INITIAL FIRE SAFETY INSPECTION REPORT

MNR Sweaters Ltd Extension Building

RSC ID: 25126

Date: 12-February-2024

Table-1: Finding & recommendation

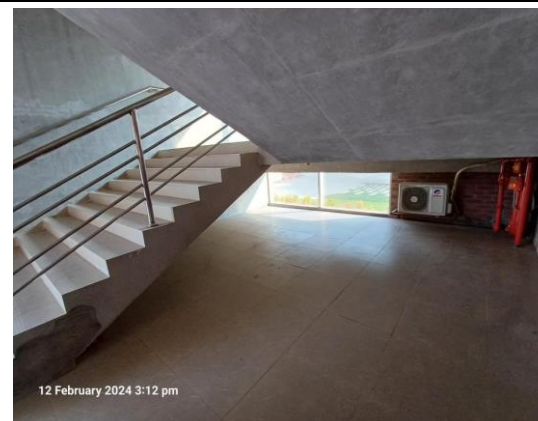
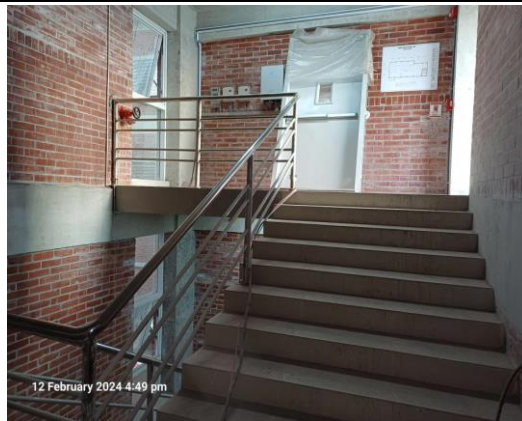
SI No.	Category	Findings	Required Action	Remediation Time Frame
F-1	Fire Rated Construction	Rooms used for storage of combustible materials discharge directly to the exit stair enclosures. Location: Factory Building: Ground, 1st floor and 5th floor Exit Stairs.	Openings from exit enclosures to storage areas, basements, transformer rooms, generator rooms, boiler rooms, and similar normally unoccupied spaces shall be provided with vestibules. Provide a 1.5 hr. fire rated door on the exit stair side and a 1- hr. fire rated door on the storage and machine room side. Ensure that the fire rating of the vestibule construction matches that of the exit stair enclosure. Seal all penetrations and unprotected openings to maintain the rated fire separation.	Within 3 Months
